Modification of Development Consent

Section 4.55(1A) of the *Environmental Planning and Assessment Act 1979*

Application Number:	SSD 7348
Applicant:	Goodman Property Services (Aust) Pty Ltd
Consent Authority:	Minister for Planning and Public Spaces
Site:	Lot 1 DP 663937, Lot 2 DP 1215268, Lot 6 DP 229784, Lot 2 DP 84578, Lot 3 DP 85393, Lot 11 DP 1178389 and Lot 9 DP 1157476 2 Aldington Road, Kemp Creek NSW 2178 57-87 Lockwood Road, Erskine Park NSW 2759
Development:	A Concept Proposal including: <ul style="list-style-type: none">• concept layout of 22 warehouse buildings inclusive of dock offices and ancillary offices providing 476,000 square metres of gross lettable area, built over five development stages;• concept layout of development lots, internal roads, drainage, landscaping, noise walls, basins and biodiversity offsets; and• development controls A Stage 1 Development including: <ul style="list-style-type: none">• bulk earthworks across all five stages including retaining walls and noise walls;• lead in services including but not limited to drainage, power, sewer, water and telecommunications;• service infrastructure to Precinct 1, including drainage, power, sewer, water

Figure 3: Stage 1 DA Layout

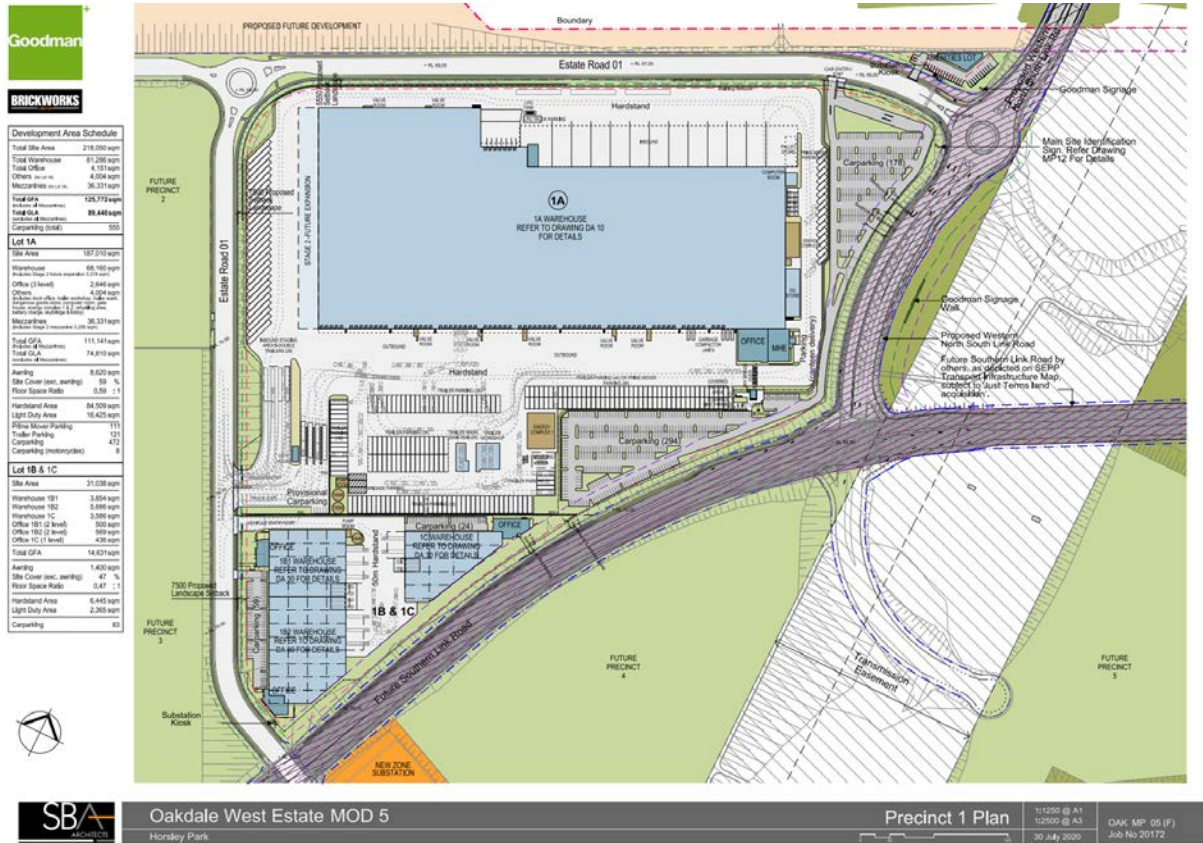
12. Delete Figure 3 and replace with:

Figure 8: Offsets for WNSLR – Planting Area

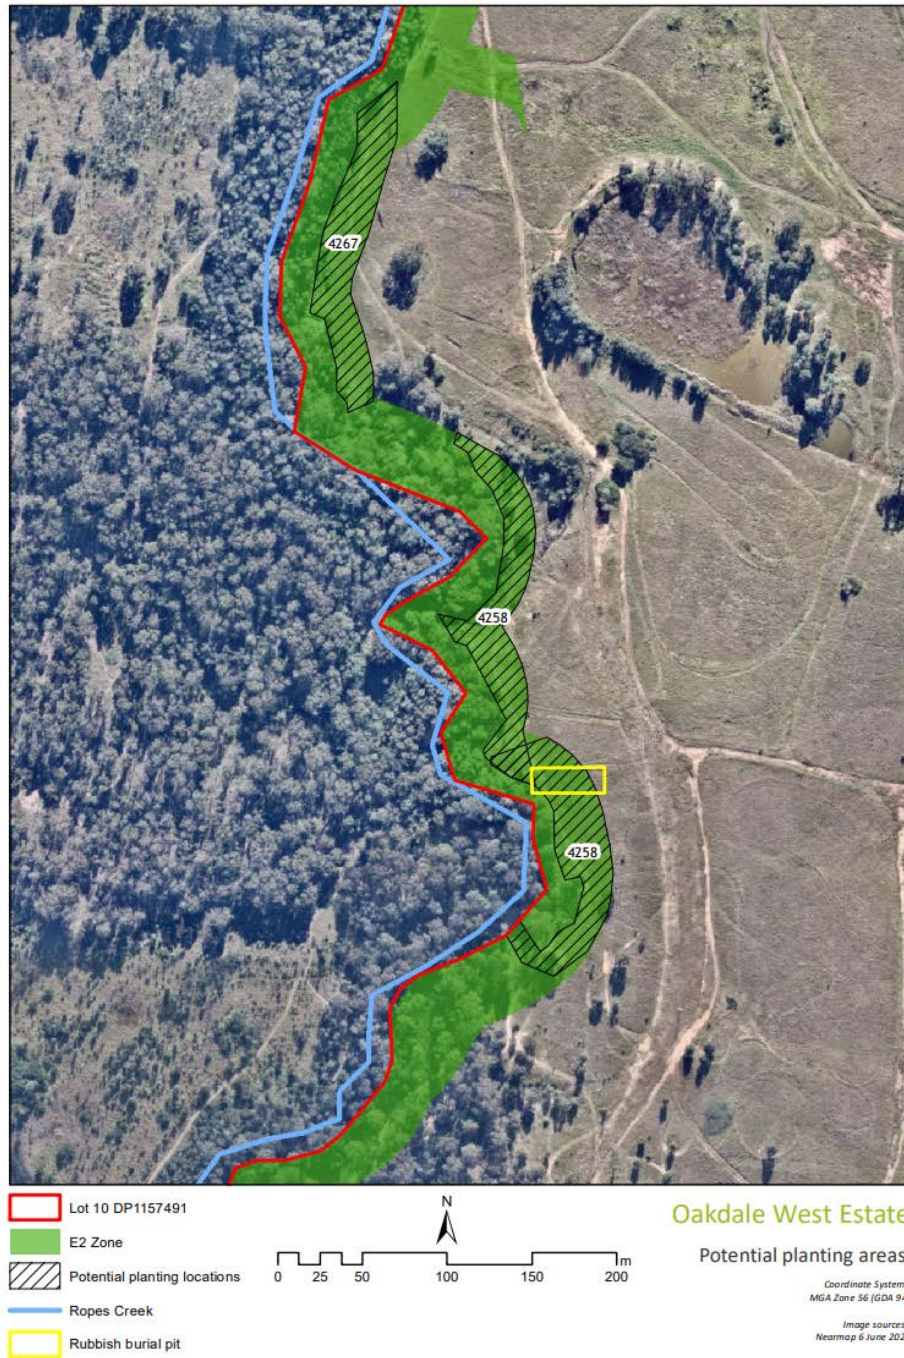
(a) offset 0.42 ha of vegetation lost in the Erskine Park Biodiversity Corridor as a result of the WNSLR by carrying out planting within the areas shown in Figure 9 in Appendix 6 at Lot 10, DP 1157491; and

(b) plant the area shown in **Figure 9** in **Appendix 6** with species similar to those identified for zone 4a, on the south-eastern side of Ropes Creek, in the Biodiversity Management Plan Erskine Park Employment Area (HLA-Envirosciences, 2 May 2006).

- 15. Update Figure 8 to Figure 7.
- 16. Delete Figure 9 and replace with:
